SUBJECT: **Request for Modification of the Section 404 Individual Permit, Section 401 Water Quality Certification, Isolated Waters State General Permit, and Neuse River Riparian Buffer Certification** for the proposed East End Connector from NC 147 (Durham Freeway/Buck Dean Expressway) to north of NC 98 (Holloway Street) in Durham, Durham County, North Carolina, Division 5. Federal Aid Project No. NHF-76-1(2), TIP No. U-0071.

The purpose of this letter is to request a modification to the United States Army Corps of Engineers (USACE) Section 404 Individual Permit and North Carolina Division of Water Resources (NCDWR) Section 401 Water Quality Certification, Isolated Waters State General Permit, and Neuse River Riparian Buffer Certification for the above-referenced project.

In addition to this cover letter, please find enclosed revised Wetland Permit Drawing Sheet Nos. 30, 53, 55, 60, 90, and 91 of 91; revised Buffer Permit Drawing Sheet Nos. 6, 16, and 18 of 18; new ABF Freight Wetland Permit Drawing Sheet Nos. 1 and 2 of 2 for new Site No. 33, which is associated with the loss of property remediation between the N.C. Department of Transportation (NCDOT) and ABF Freight Corporatio

1 TRUCK TURNAROUND EXHIBIT
X-1 SCALE: 1"=40'

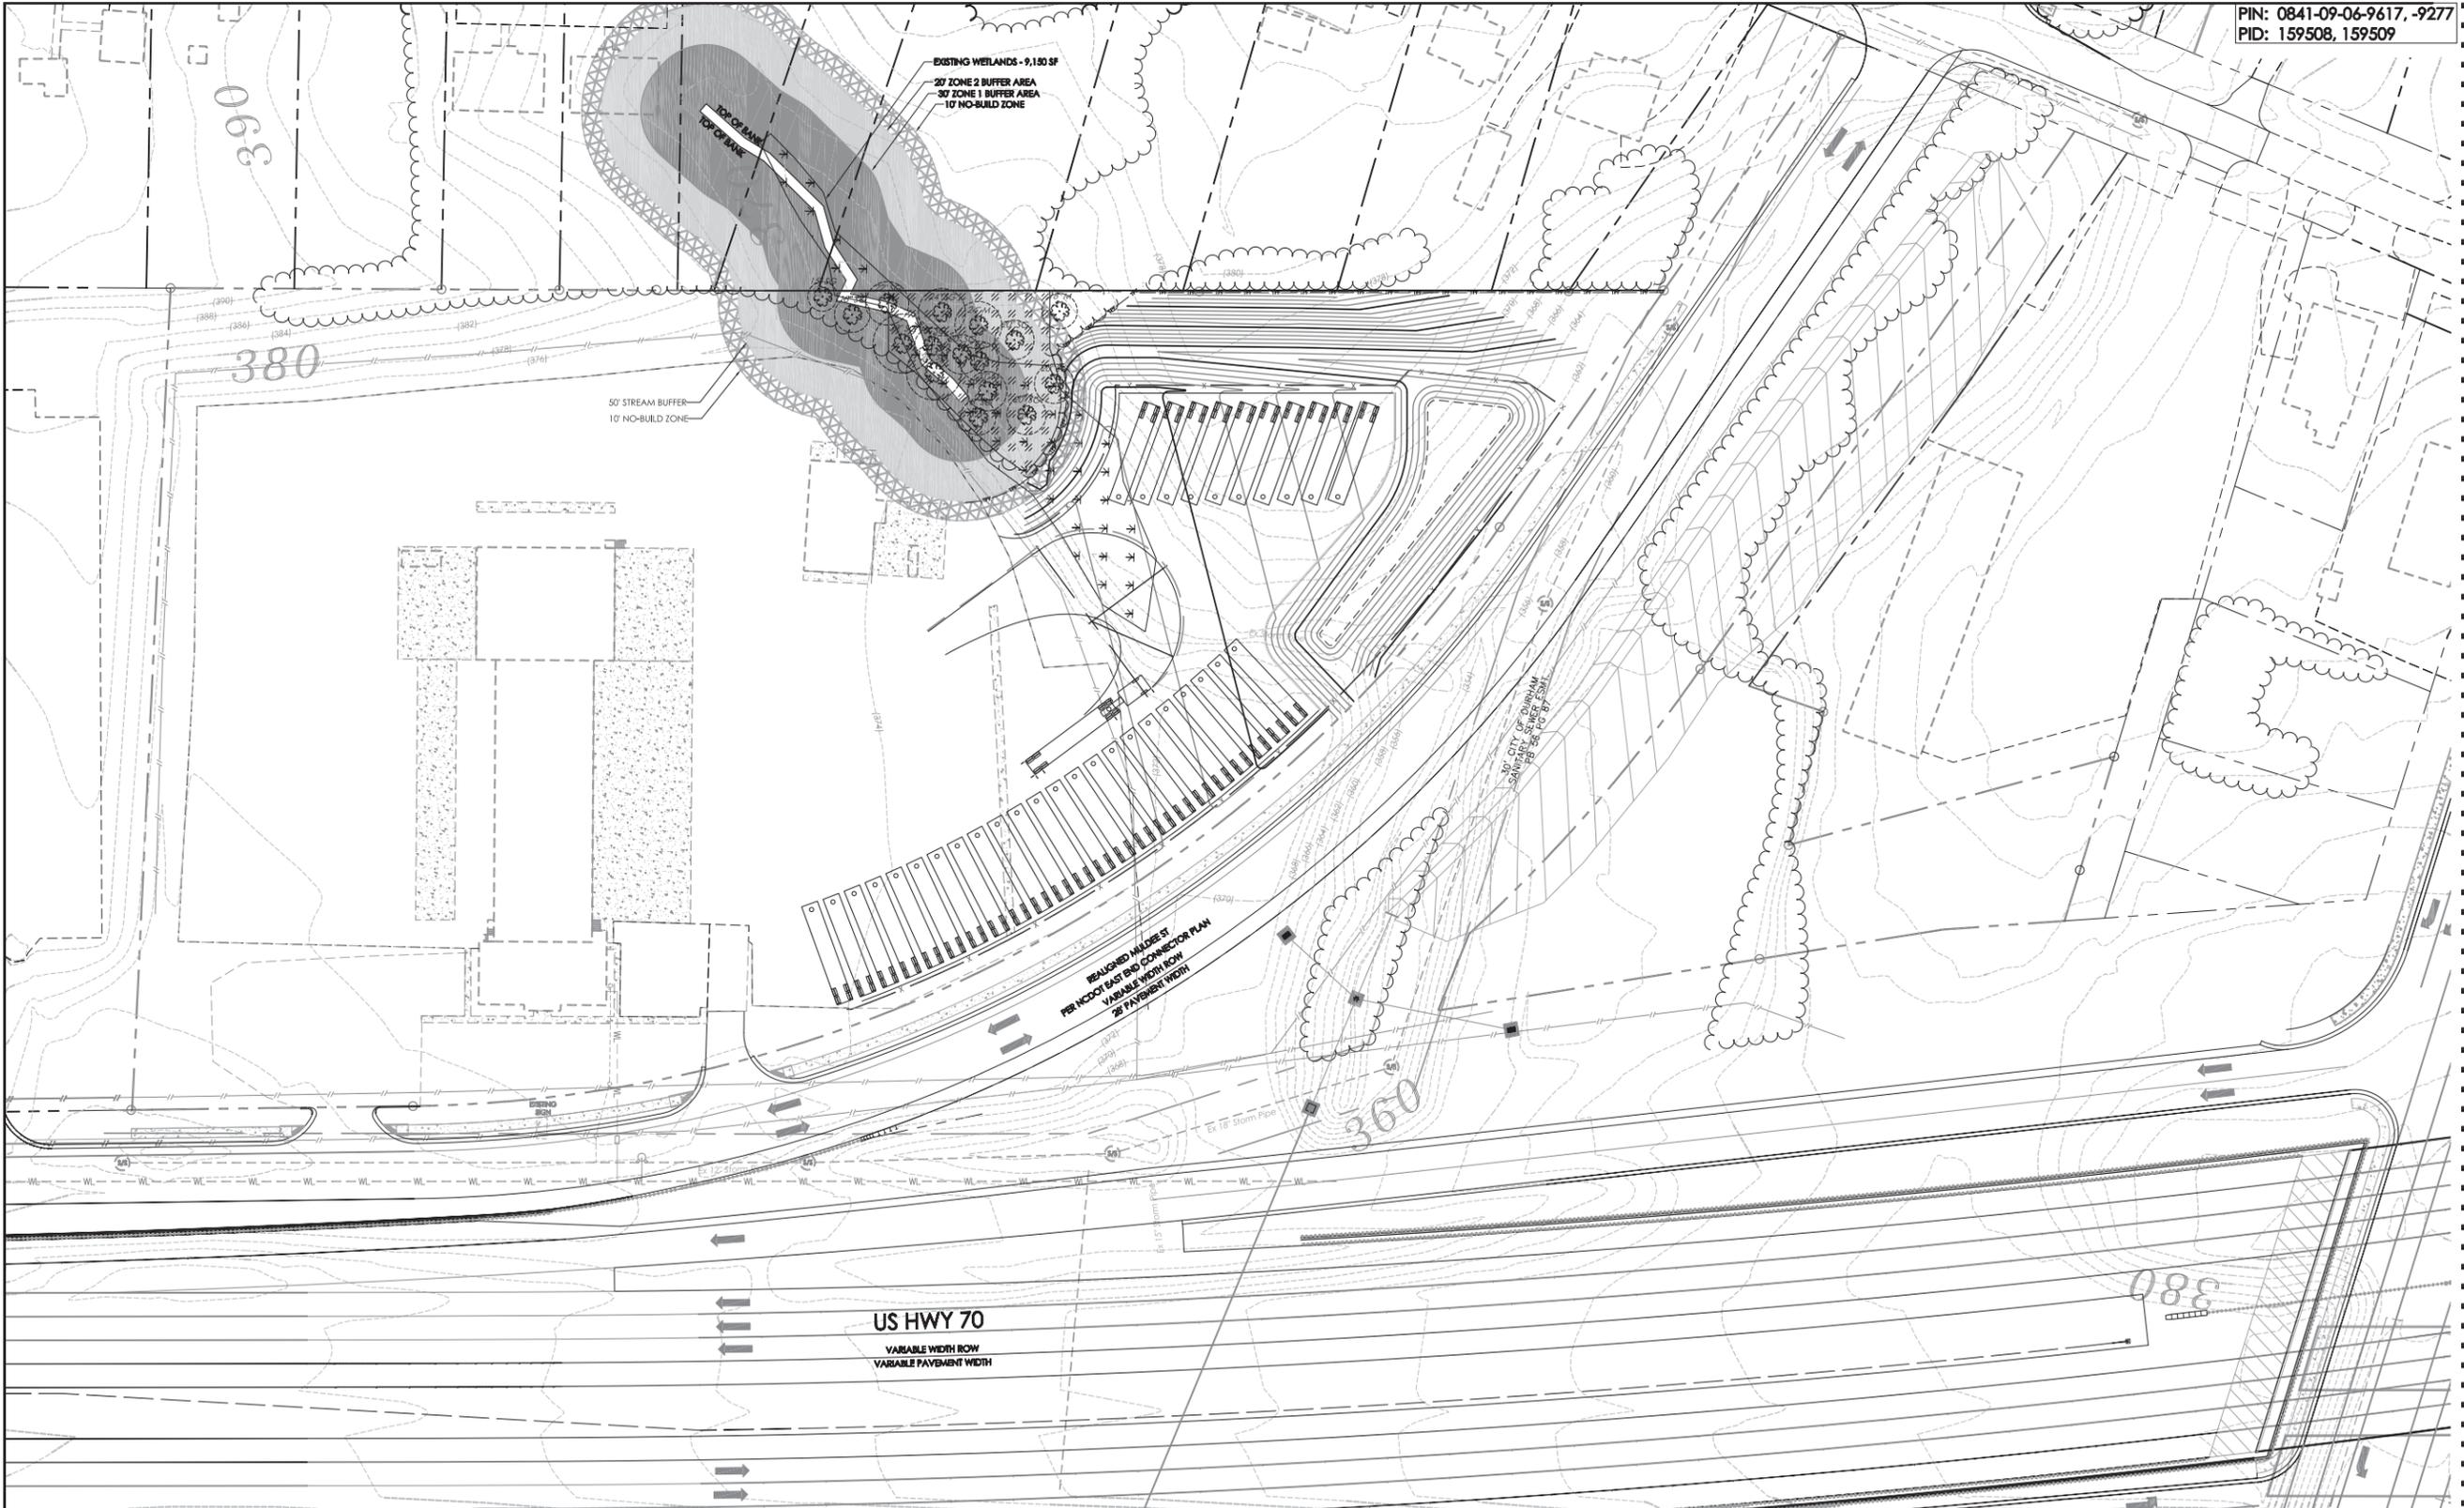
As you are aware the ABF Freight Corporation, Horvath Associates, and NCDOT have been working on a plan to remediate the loss of property due to the U-0071 project on the ABF Freight Parcel located at 208 Muldee Street in Durham, North Carolina. The plan consists of replacing the lost truck terminal parking spaces and necessary truck turning movement area on an adjacent property which will remain outside of the limits of the right of way upon completion of project U-0071. Inside the proposed limits of disturbance for this replacement parking and movement area there is a small portion of an isolated wetland (approximately 4,000 SF \pm) that needs to be disturbed in order for the replacement parking areas to reasonably function for the intended uses. Provided with this letter is a truck turnaround exhibit which clearly shows that for proper truck movements to occur and for the replacement area to be used as needed by the ABF Freight Corporation, the disturbance of this wetland area is unavoidable. It should be noted that a large portion of this wetland will remain undisturbed and that this request is only for disturbance of the area necessary for the site to function properly.

PERMIT DRAWING
SHEET 55 OF 91
 Revised April 2016

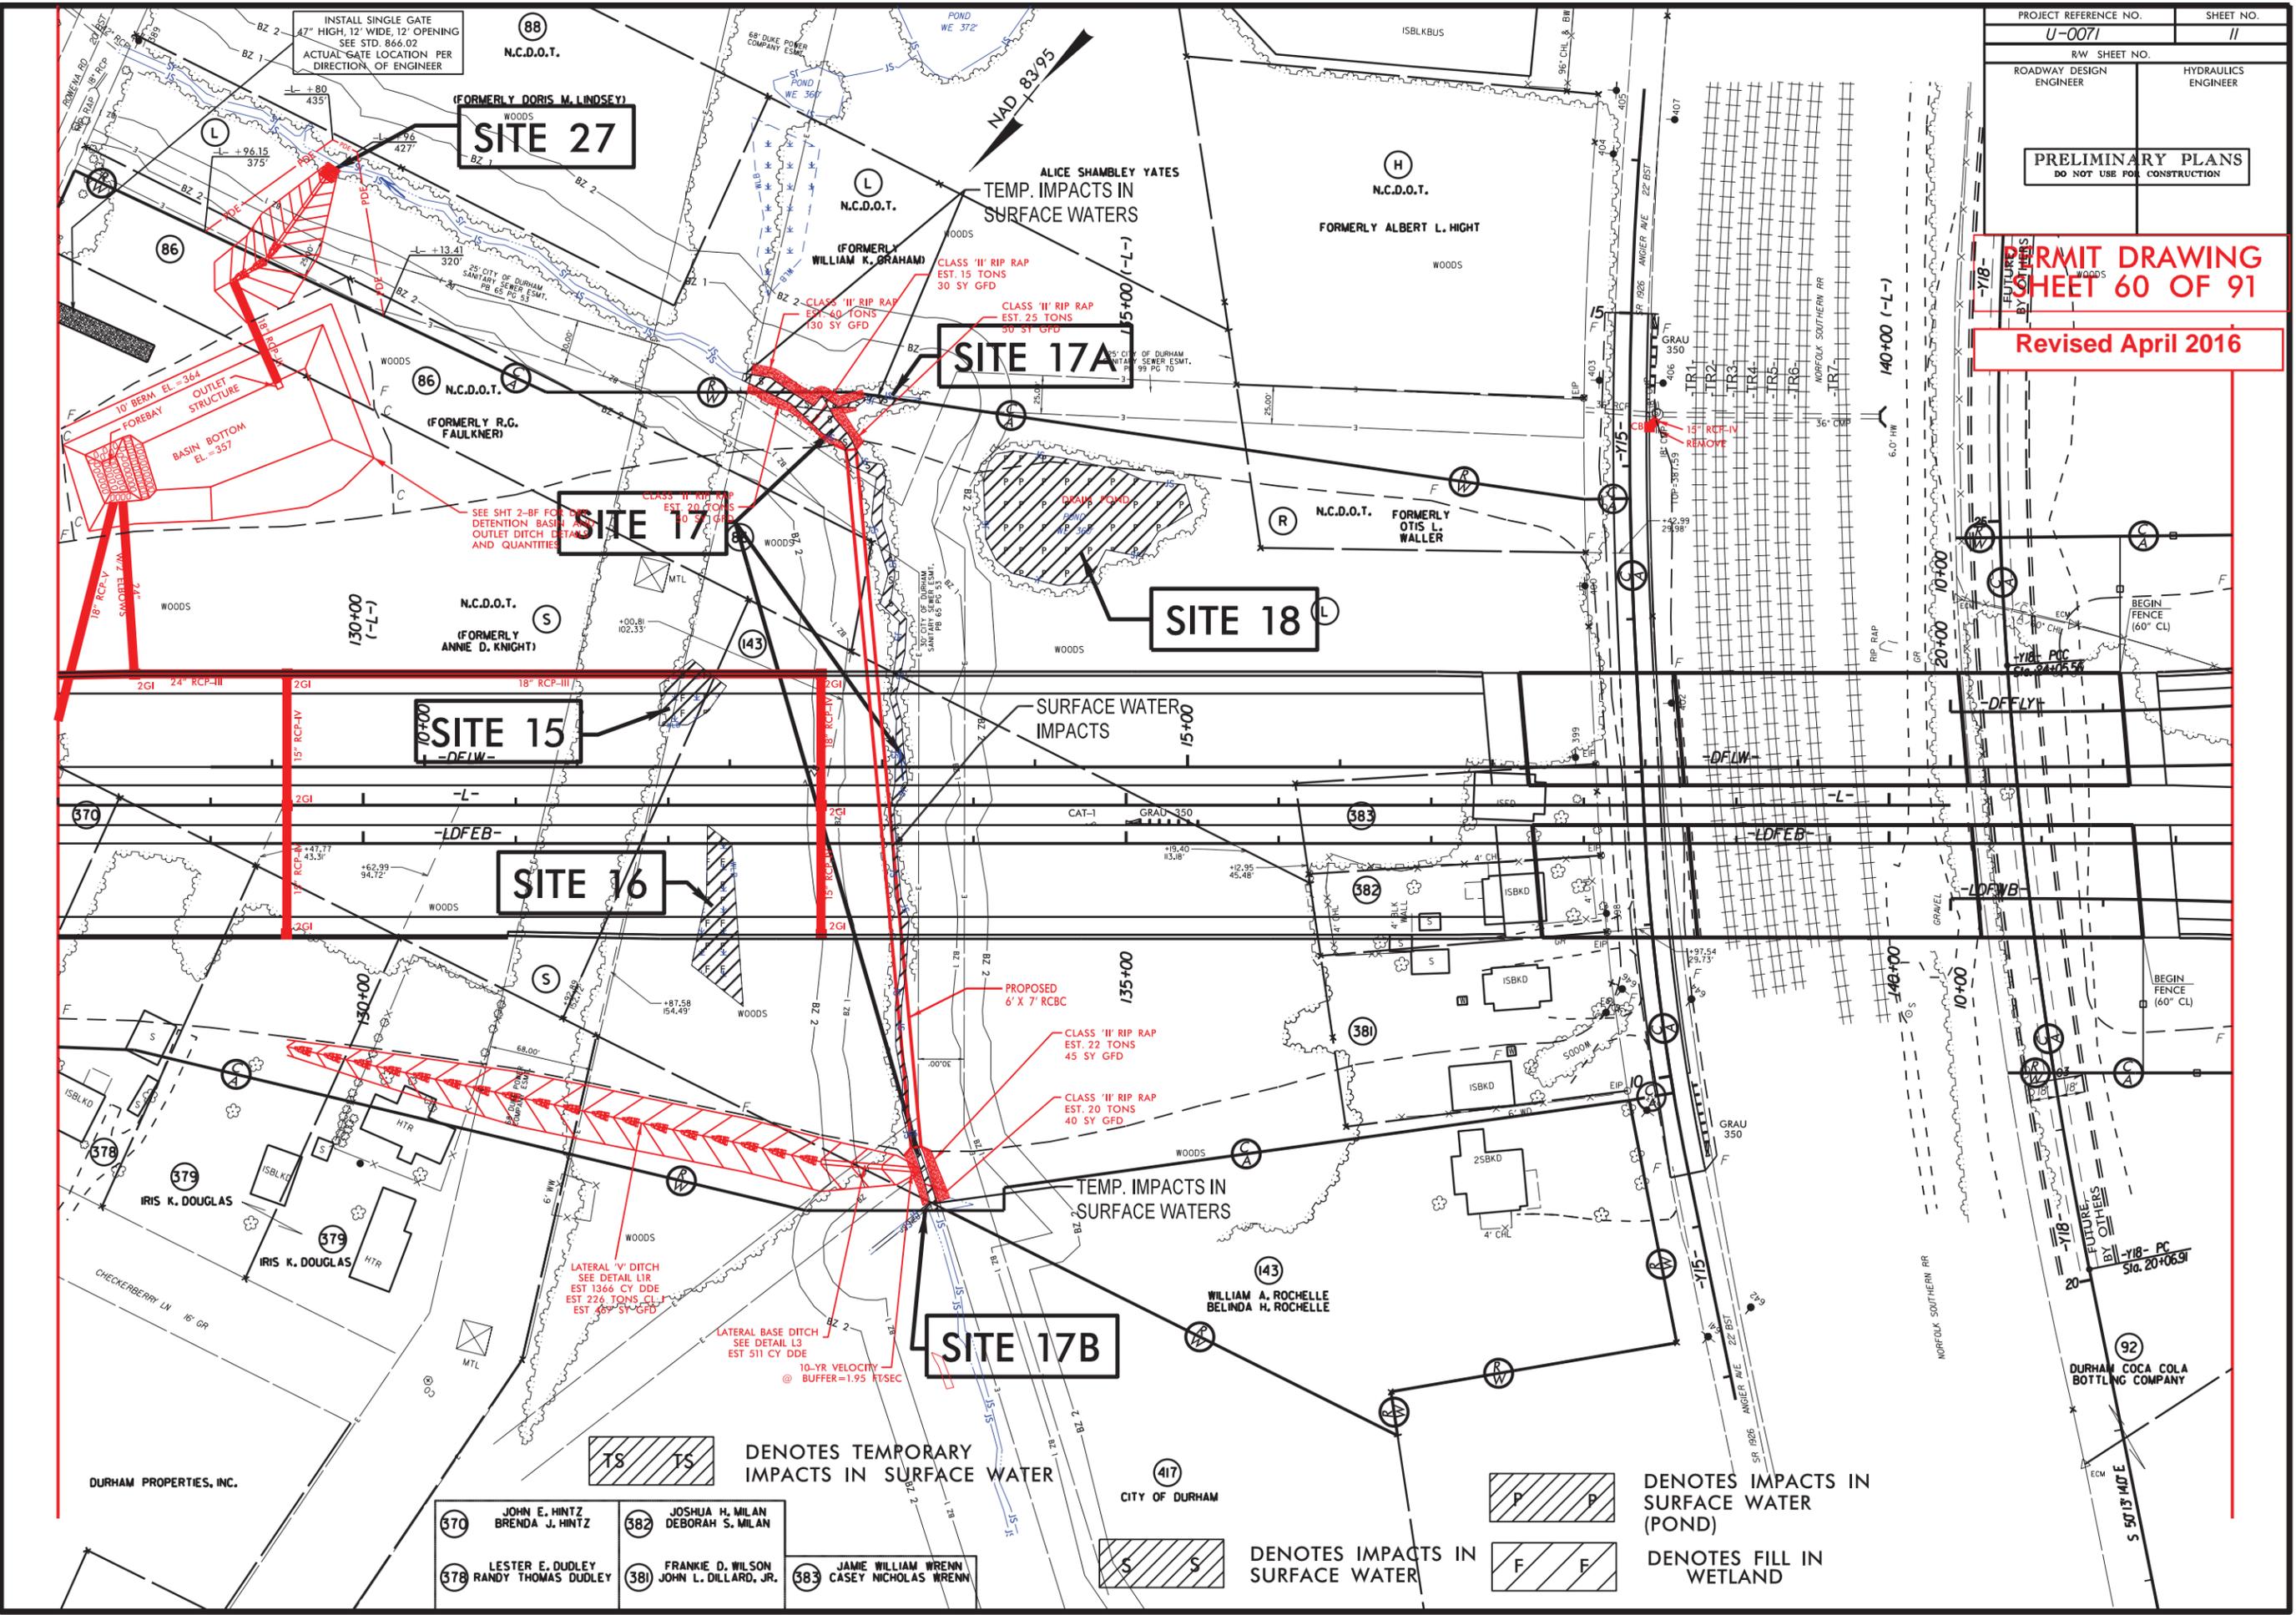
Permit Site 12 (Permit Drawing 53 of 91 and 55 of 91) at 25+50 -Y2- Rt

- Installation of the complete hydraulic system will result in an increase in runoff velocity during heavy rain events at this location. The Department has evaluated the existing stream channel and determined that the channel should be lined with a rip rap-lined 3 foot-base ditch to provide long-term stability.
- This design change will result in a decrease in temporary stream impacts of 60 linear feet, an increase of permanent stream loss impacts of 84 linear feet, and a decrease in permanent bank stabilization impacts of 24 linear feet.
